UNITED STATES PATENT AND TRADEMARK OFFICE

10/517,866

Office Action Summary	Application No. 10/517,866	Applicant(s) SUWABE ET AL.	
	Examiner NICOLE T. GUGLIOTTA	Art Unit 1794

DETAILED ACTION

FIG. 4(a)

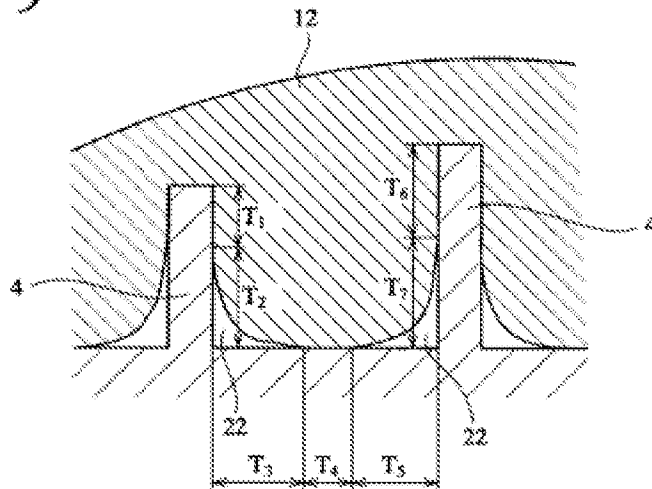
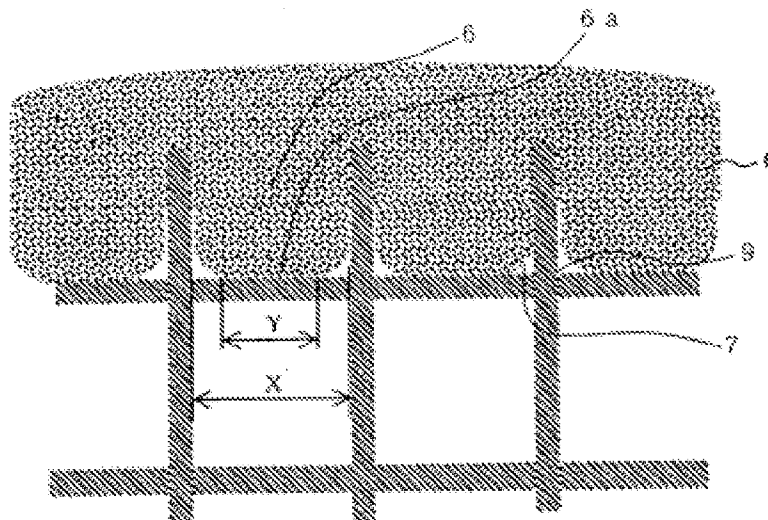
10. In regard to claims 1, 33, 36, JP '836 disclose (Figure 4(a) shown above) a ceramic honeycomb structure comprising grooves (6a) on its periphery and cell walls, a peripheral wall (6) covering said grooves (6a), wherein there are stress release portions (gaps, 7), at least partially between said peripheral wall layer and said grooves. These

stress release portions (gaps, 7) retain heat and improve thermal conductivity (Sections [0018] and [0019]). The peripheral wall is formed by a slurry coating. The viscosity of this slurry may be adjusted to prevent the slurry from contacting the corner section (9) to form gap (7) (Section [0032]).

16. In regard to claim 35, JP '836 disclose a contact ratio (Y/X) of 0.7 (70%) (Section [0019]). Y and X are illustrated in Figure 4(a) of JP '836.

30. In regard to claims 39, 40, 45, JP '836 disclose (Figure 4(a) shown above) a ceramic honeycomb structure comprising grooves (6a) on its periphery and cell walls, a

peripheral wall (6) covering said grooves (6a), wherein there are stress release portions (gaps, 7), at least partially between said peripheral wall layer and said grooves. These stress release portions (gaps, 7) retain heat and improve thermal conductivity (Sections [0018] and [0019]).

31. In regard to claim 42, JP '836 disclose a contact ratio (Y/X) of 0.7 (70%) (Section [0019]). Y and X are illustrated in Figure 4(a) of JP '836.

Fig. 5

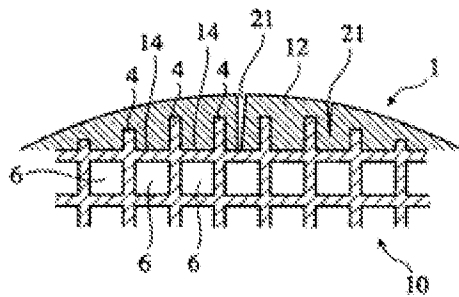
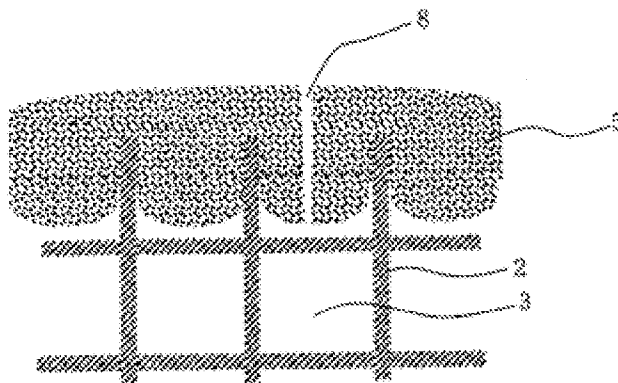
15. In regard to claims 28, 29, 31, and 32, JP '836 further discloses stress release portions (voids, 8), which correspond to applicant's "voids/stress release portions in the peripheral wall" (21, Figure 5), in Figure 3(b) shown above. Examiner takes the position "crack" and "slit" are analogous.

35. In regard to claim 46, JP '836 further discloses stress release portions (voids, 8), which correspond to applicant's "voids/stress release portions in the peripheral wall" (21, Figure 5), in Figure 3(b) shown above. Examiner takes the position the terms "crack" and "slit" are analogous.
